## PROJECT AUDIT (PEER REVIEW) REPORT

**SUBJECT:** Independent Evaluation and Audit (Peer Review) of the WSSC Water 48-Inch Patuxent Raw Water Main Project - BF1582E91

**RELEASED DATE:** November 19, 2025

Figure 4-1 Geotechnical Challenges

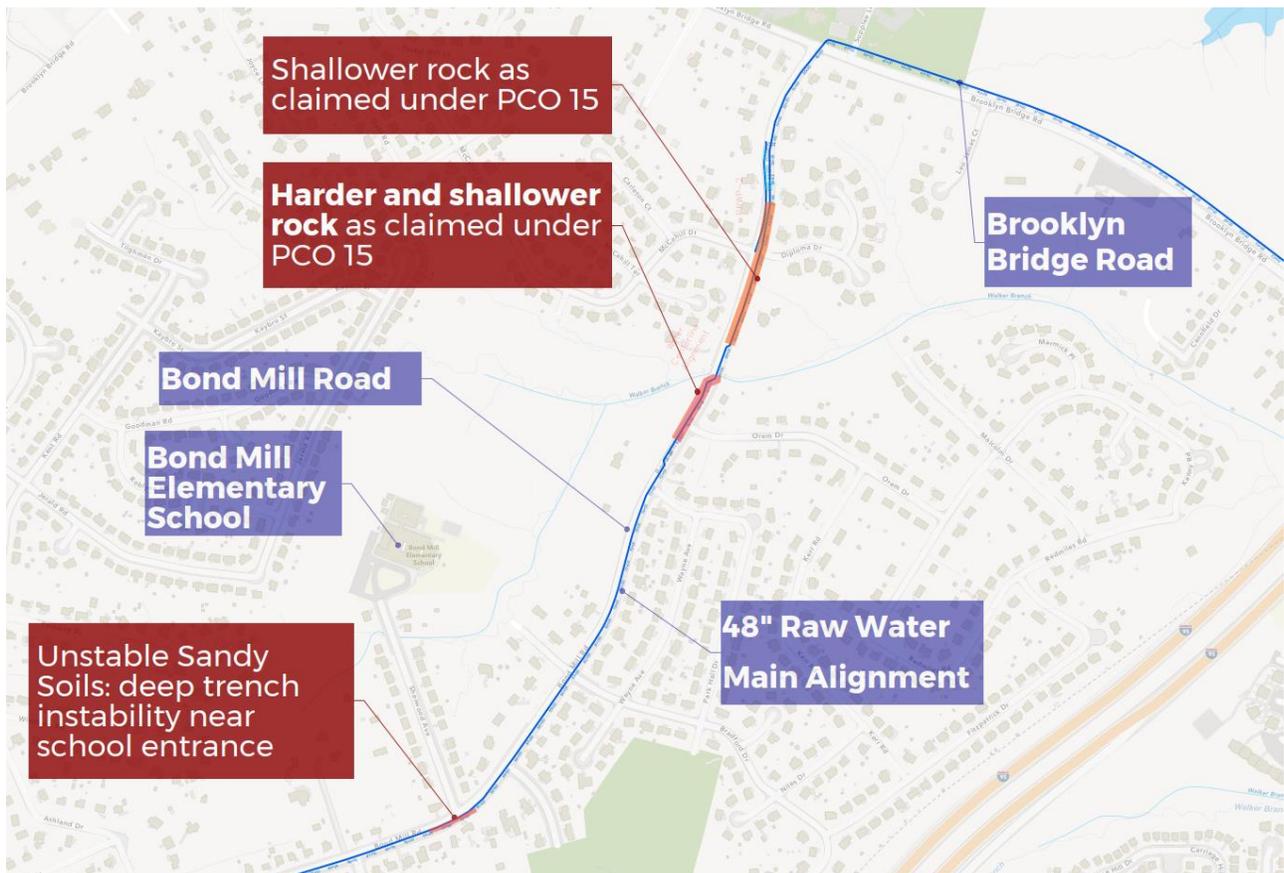
- Rock elevation between Borings B-22, B-23, B-24, B-25 and B-26 (approx. Station 57+50 to 72+00). Upon reviewing the daily inspection reports and PCO #15 indicating the rock was encountered at these locations above the pipe inverts, the rock encountered appeared shallower (Station around 57+50 to 67+00) also shallower and harder than identified in the boring logs (Station 67+62 to 70+00).
- Unstable saturated sand in a deep trench near borings B-33 to B-35 (around the pipeline low point by Bond Mill Elementary School, ~Station 90+50 to 92+50).

- **The boring at location B-26 did not reflect the final design changes:** B-26 was drilled at the preliminary alignment on the east side of Bond Mill Road during the planning phase, but the water main construction alignment was later moved to the west side of the road, likely due to utility conflicts with the gas and sewer mains. Historical plans show that Bond Mill Road was previously narrower, and existing utilities were installed within this original corridor, which is the current east side of the Bond Mill Rd. The updated water main alignment, where hard rock was encountered, extends beyond the original roadway area. As a result, the B-26 boring location does not accurately represent the subsurface conditions for the final design alignment.

**Information not being updated due to prolonged project timeline and team changes:** WSSC Water reviewed the geotechnical reports and requested updates to boring logs to classify as bedrock in B-23 and B-24, and to note where rock excavation would be needed. Because EBA was no longer with WRA’s design team when comments were provided in 2018, the report and boring logs were not revised. WRA added a statement in the N&W addendum indicating rock excavation could be required between STA 0+00 and STA 69+00.

**Information not provided during bid phase:** The bid drawing general note referenced an “Appendix of the Contract Documents for the geotechnical report, The Contractor shall become familiar with the site and the subsurface conditions,” indicating that the design team planned to share the geotechnical investigation results with the Contractor. However, the EBA geotechnical report and N&W geotechnical addendum were not included in the original bid package; only the boring logs were present in the contract documents. These reports were also not provided to the Contractor at the start of construction or when WSSC Water was first

**Lack of mandatory shoring requirements:** Despite the geotechnical report recommending that “excavation support systems be required to support the sides of excavations... to minimize impacts to roads and utilities”, the contract left the means and methods of trench support largely to the Contractor. The contractor drawing did include general note indicating excavation supporting and dewatering systems are the responsibility of the contractor. There was no specific instruction like “Use sheet piling or engineered shoring at Station 90+50–92+50 due to expected running sands.” As a result, the Contractor initially attempted conventional trench shoring and only switched to sheet piles reactively after failures occurred. This caused a delay and could have created hazardous conditions. A design identifying the need for more extensive trench support in this location (and allowed cost/time for it) would have been more appropriate.

- **Explicit communication of geotechnical risks:** All critical findings from the geotechnical reports—such as wet running sands, high groundwater, unstable soils, etc.—should be clearly communicated in design documents and emphasized during pre-bid meetings. This enables contractors to plan for suitable construction methods and safety provisions, minimizing reactive alterations and delays.

- **Mandatory safety measures in design:** Design plans could require specific excavation support systems and contingency plans (such as shoring or dewatering) where adverse ground conditions are identified in the geotechnical investigation, rather than leaving these critical decisions solely to the Contractor.

- **Regular updates to reports and logs:** Geotechnical reports and boring logs should be updated throughout the project, especially if timelines are extended or teams change, to ensure all information remains current, accurate and actionable.

- **Conducting supplementary geotechnical investigations at key locations:** Conduct targeted geotechnical investigations in areas anticipated to pose construction challenges, where design changes occur between phases, or where previous data is insufficient. This proactive approach helps better identify ground conditions, such as unexpected rock formations or unstable soils, allowing for improved planning, risk management, and communication in design documents. WSSC Water 2017 design manual has added additional instructions related to the boring spacing and depth requirements which addresses some of the gaps as shown on this project. It is recommended the design team and constructability review to identify the potential geotechnical risks with the initial investigation and
